MONTGOMERY COUNTY HISTORIC PRESERVATION COMMISSION
STAFF REPORT

Address:	113 Elm Ave., Takoma Park	Meeting Date:	7/23/2025
Resource:	Contributing Resource Takoma Park Historic District	Report Date:	7/16/2025
Project Contact:	Brian Rowland	Public Notice:	7/9/2025
Review:	HAWP	Tax Credit:	Partial
Case Number:	1116058	Staff:	Dan Bruechert
Proposal:	Door and Window Replacement

Figure 2: 1927 Sanborn (left) showing the original, partial-width rear porch. 1953 Sanborn (right) shows full-width rear.

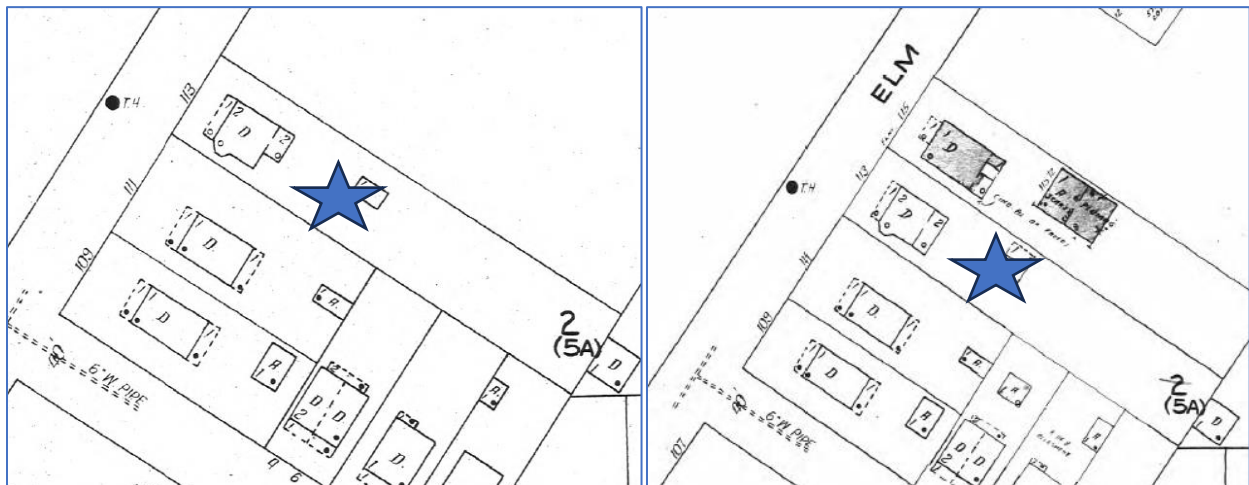
The subject property is a two-story Colonial Revival house, with a stucco sided front porch with aluminum siding on the second. At the front, there is a floor full-width front porch with second-story access. Based on Sanborn Fire Insurance Maps, the rear of the house has been modified so that it now has a full-width addition across the rear (see *Figure 2*, below). As identified in the 2020 HAWP Staff Report, linked above, the subject house was constructed by John Raines, a local carpenter responsible for constructing many of the neighborhood houses. It appears that Mr. Raines made several alterations to the house after its construction including widening the rear, altering the roofline, and other material changes.

Figure 5: 1920 Plat showing the subject property (lot #24) and its neighbor separated by an alley.

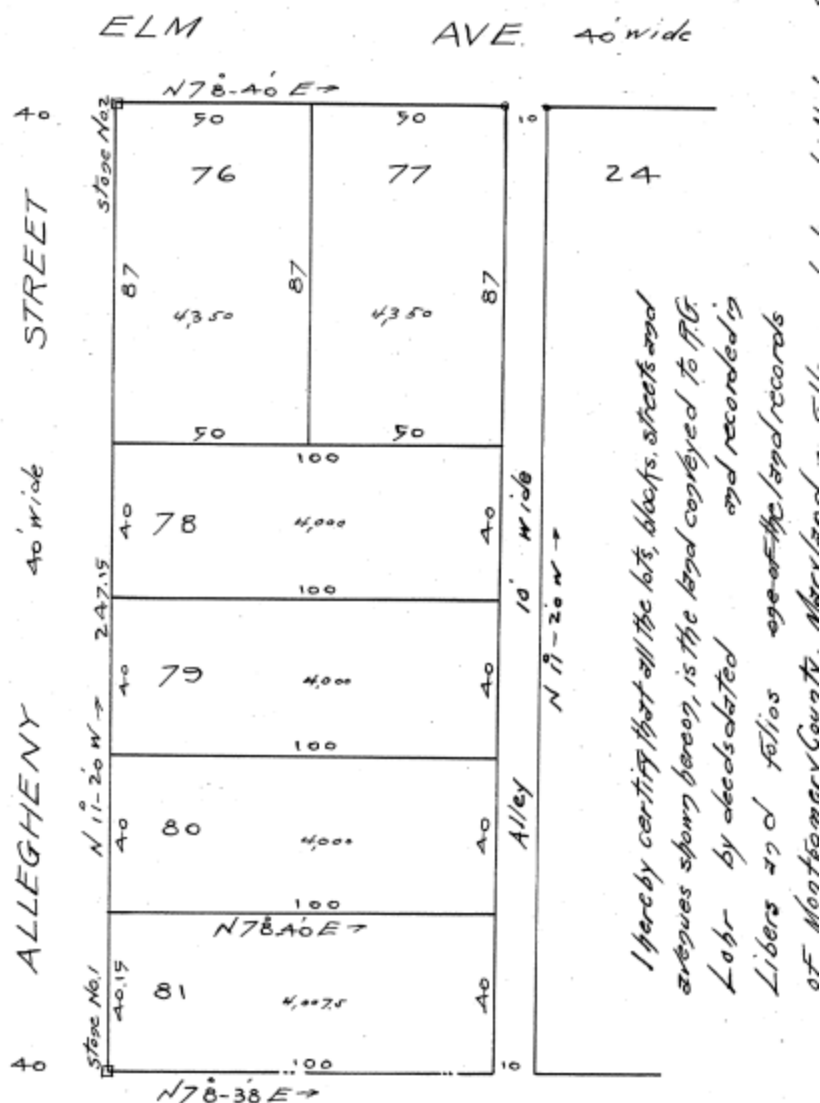
Second, Staff finds that seven of the eight windows are visible from the public right-of-way along the right side. *Figure 4*, below shows the highly visible right elevation. A 10' (ten foot) wide dedicated alley between the houses at 113 Elm Ave. and 111 Elm Ave. will preserve the open space between the properties and maintain the open appearance of the left elevation.

EXTERIOR
ELEVATIONS

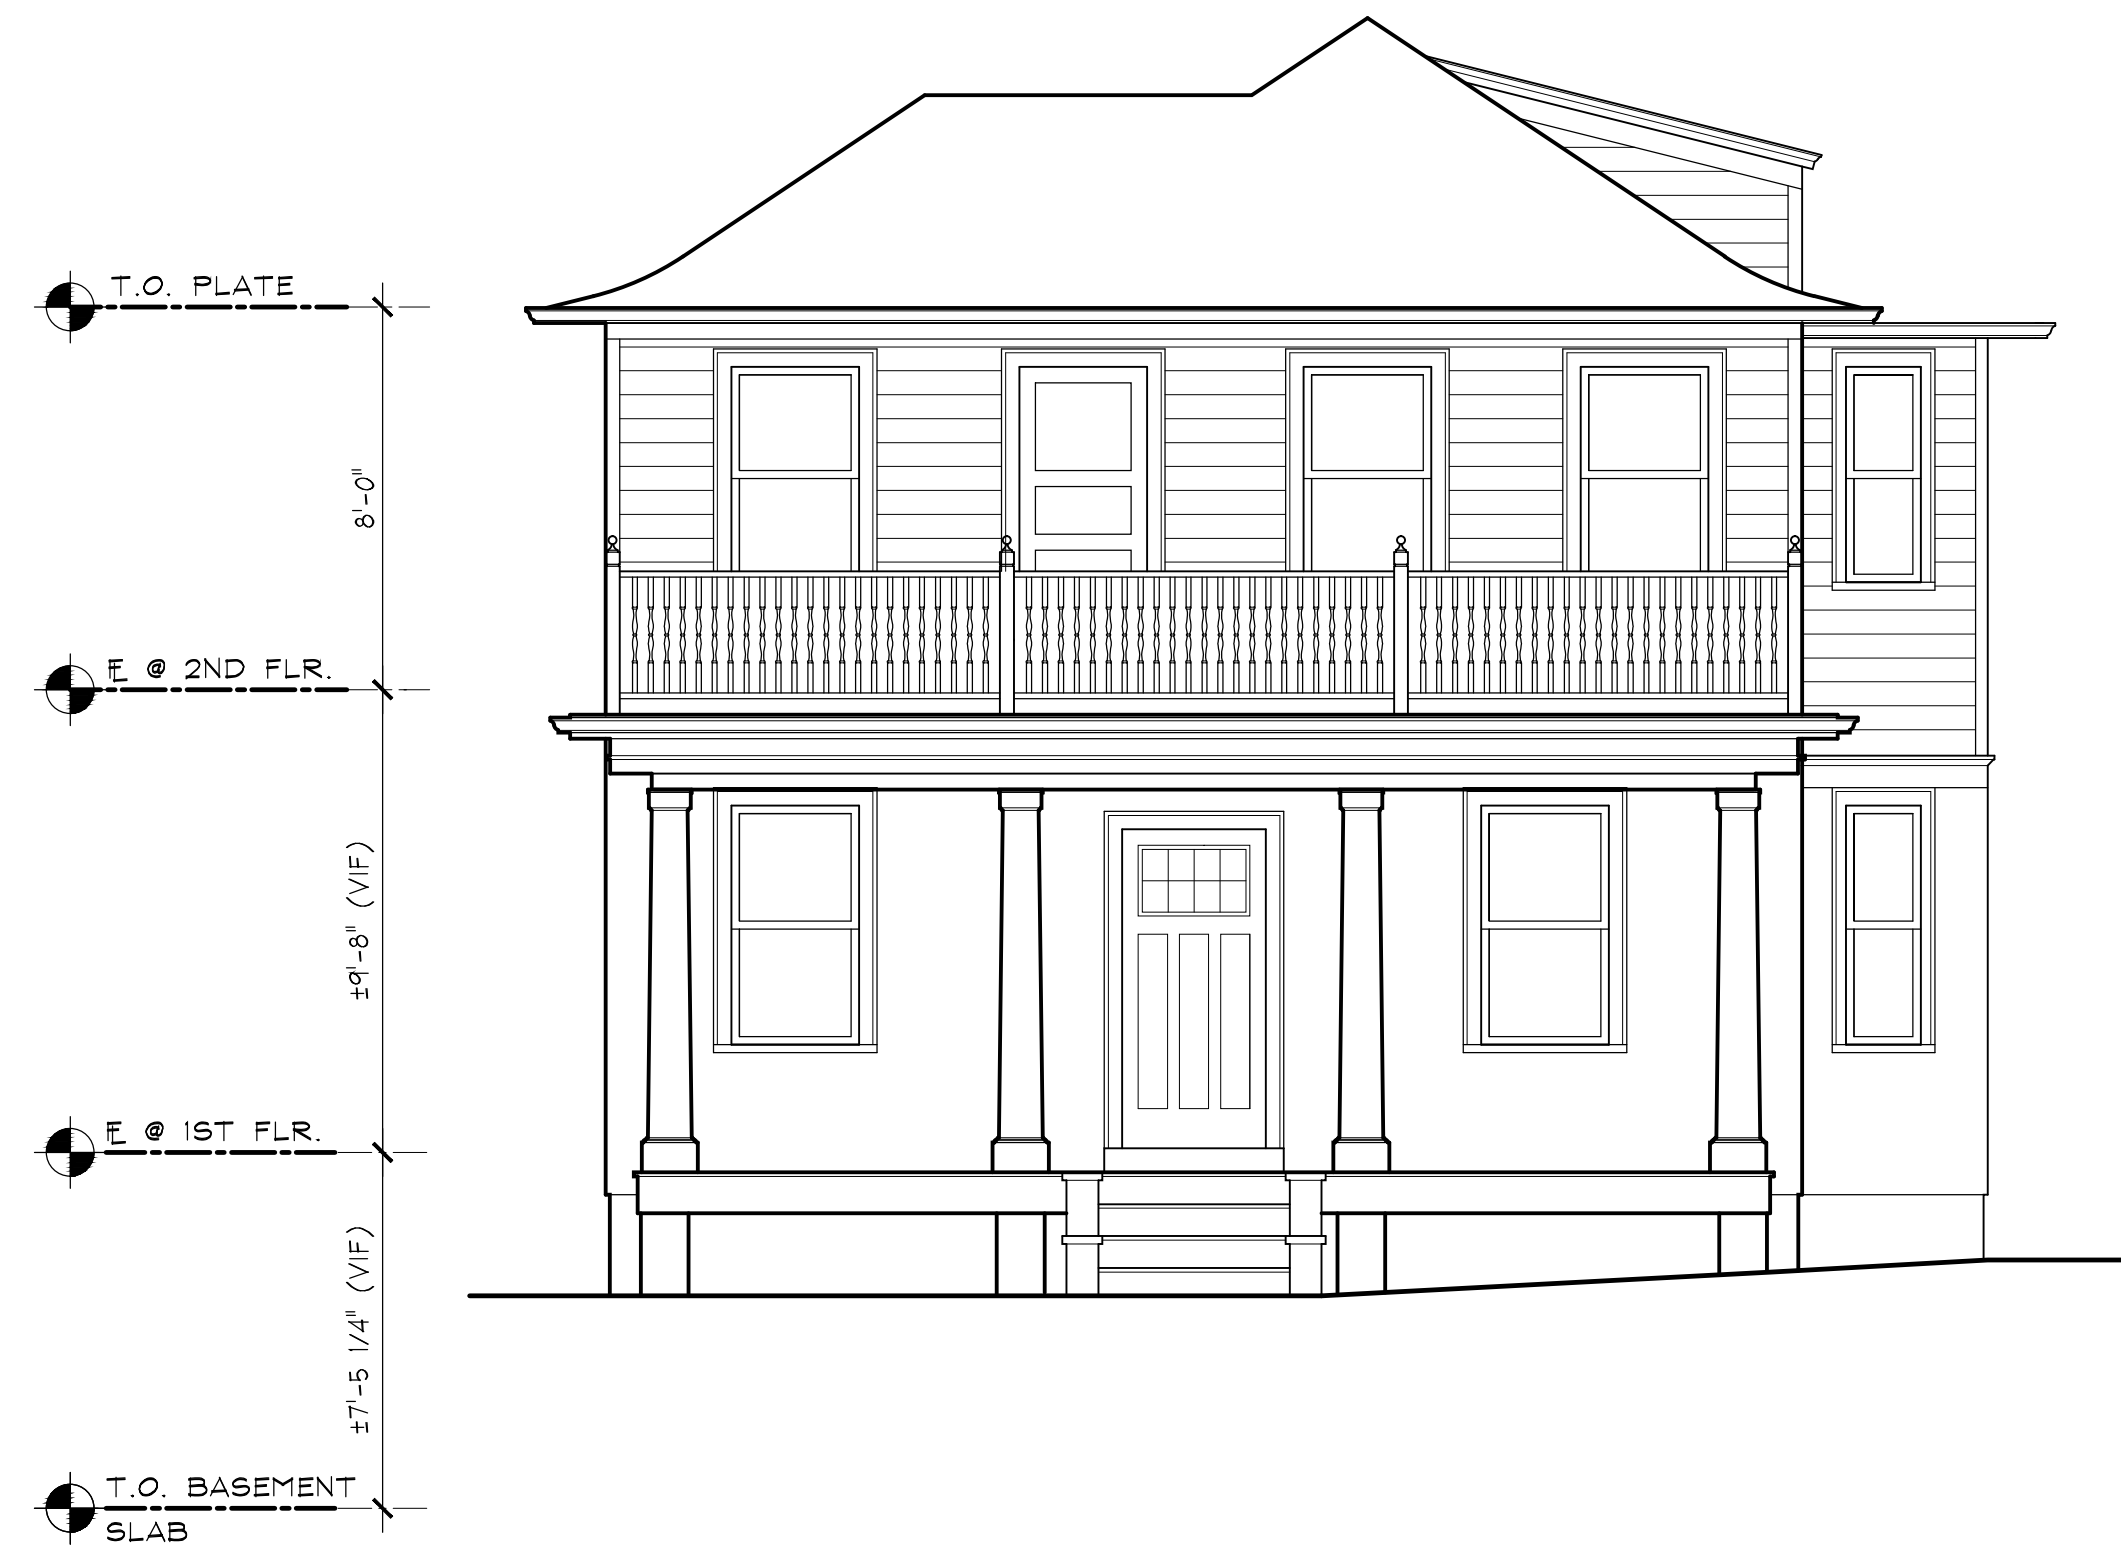
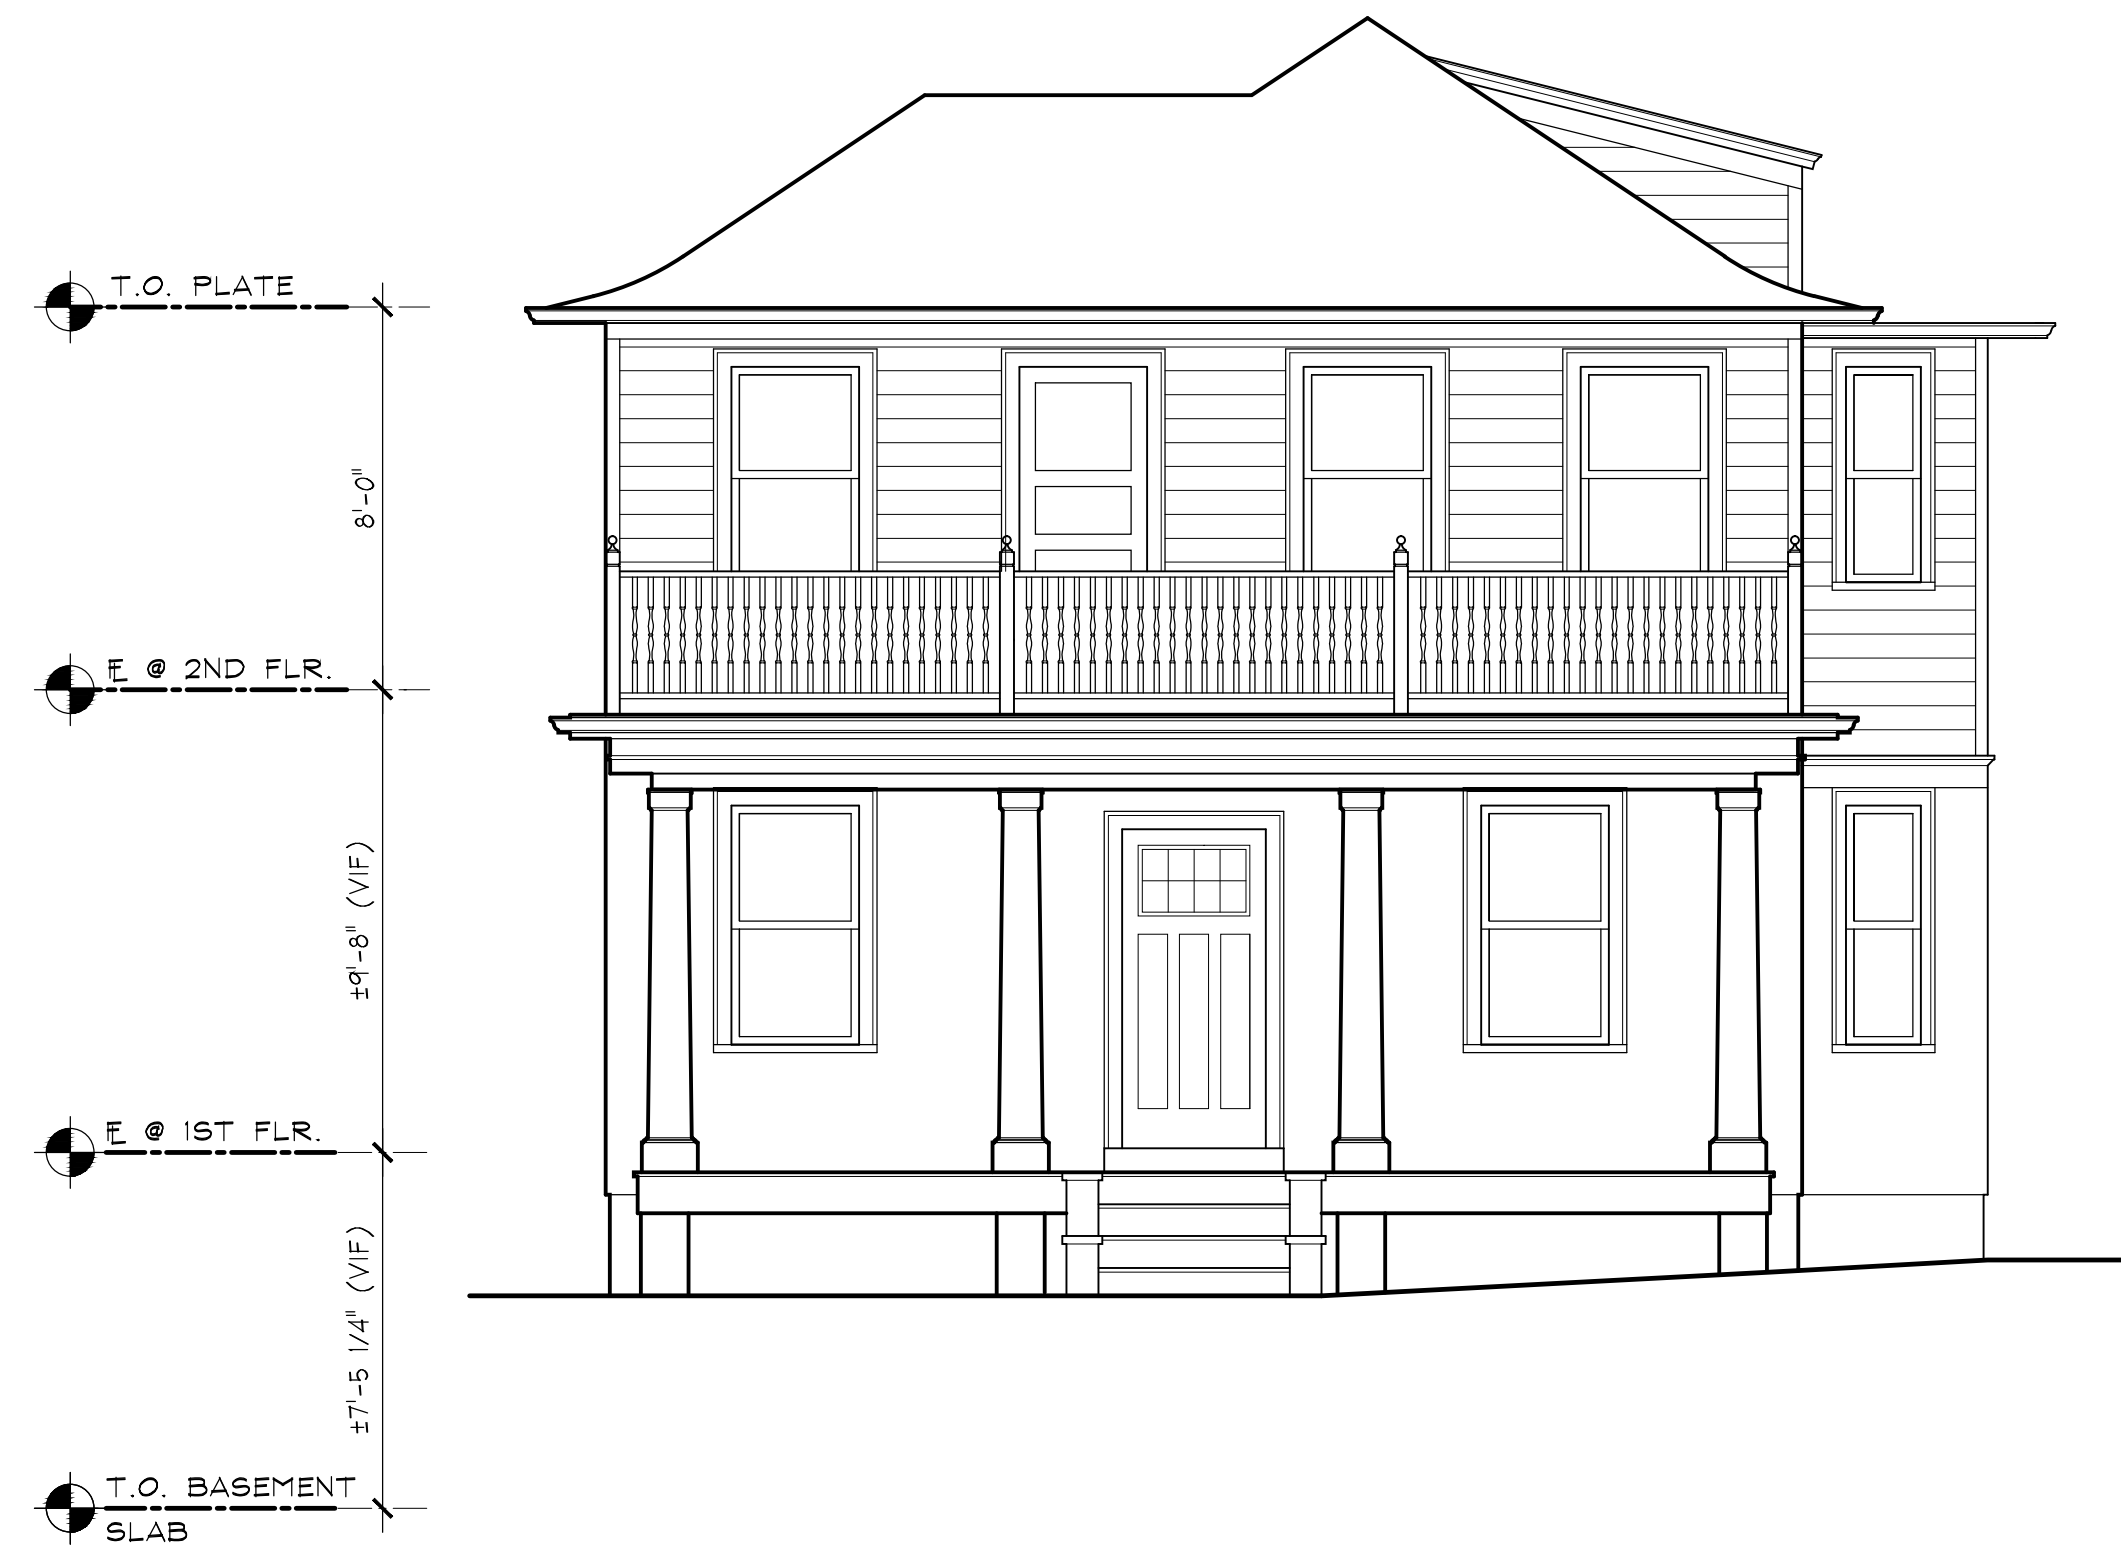
The applicant proposes to remove and replace a total of eight windows (see *Figure 3*, below). Seven of the proposed window removals are on the left side and one is on the rear. The windows on the right elevation are one-over-one wood sashes and Staff finds their appearance and condition are consistent with the house's 1913 date of construction. The window on the rear is a two-over-two sash window that appears to have been installed when the rear was expanded, between 1927 and 1959.

Based on the information included and the application and Staff's observations at a site visit, the windows show signs of paint failure, joint failure, surface mold, and rot within the frame. Due to these issues, the sashes are no longer weathertight. Surprisingly, the sash cords in several of the windows are still present.

In place of the existing windows, the applicant proposes to install Pella Lifestyle, aluminum-clad wood windows in matching size in one-over-one configurations and to replace the trim in matching dimensions. Staff finds the profiles and proportions of the proposed windows are compatible with the existing windows. The outstanding issue is the material. The HPC has consistently approved appropriately detailed clad wood windows for additions and new construction throughout the Takoma Park Historic District. However, evaluation of a substitute material on Contributing resources has been undertaken on a case-by-case basis. The primary considerations of the use of substitute materials include, design significance of the feature, visibility from the public right-of-way, and compatibility of the substitute material's appearance. Considering these criteria, Staff finds the proposed window is not appropriate.

First, Staff finds that historic wood windows are almost always considered character defining features. The size, profile, placement, and finish are all significant characteristics of wood windows. In addition to evaluating the proposal under the *Design Guidelines*, Staff looks to *Standard #6* for the recommended treatment for replacement windows. *Standard #6* states that when the severity of deterioration requires replacement of a distinctive feature (as Staff recommends, above), the new feature will match the old in design, color, texture, and where possible materials. Staff finds these criteria can be satisfied with a one-over-one wood window. While Staff does not take a position on the appropriateness of any specific color for the subject property, it does find that a wood window would successfully replicate the texture and materials.

Third, Staff finds that while the finish quality of aluminum clad wood windows is coming closer to a painted wood window, it still does not match the appearance. Most factory finished aluminum clad wood windows are shinier than a painted wood window and do not develop a patina like a wood window will.

For these reasons, Staff finds that wood is the only appropriate material for the proposed seven windows on the right elevation.

Having reached this conclusion, instead of denying the window replacement, Staff recommends the HPC conditionally approve the seven one-over-one wood windows that are appropriately sized to fill the historic opening, with final approval authority delegated to Staff. This will allow the applicants to continue to move the project forward without having to wait for a future HPC meeting, when the commission has already determined the appropriate requirements for this feature. If the applicants have additional questions about an appropriate window, Staff can direct the applicant to several window manufacturers who produce wood windows that have been installed in the Takoma Park Historic District.

Staff finds the proposal to replace the rear window with an aluminum clad window is appropriate primarily because the *Design Guidelines* apply a much more lenient standard to elements that are not visible from the right-of-way; and because this window opening is part of a later addition to the house. An aluminum clad window in this window opening would not qualify for the tax credit.

1. Replacement windows on the right elevation must be wood, one-over-one sash windows. Detailed specifications must be submitted to Staff prior to installation.
2. The replacement door must be a wood half-light door. Detailed specifications must be submitted to Staff prior to installation;
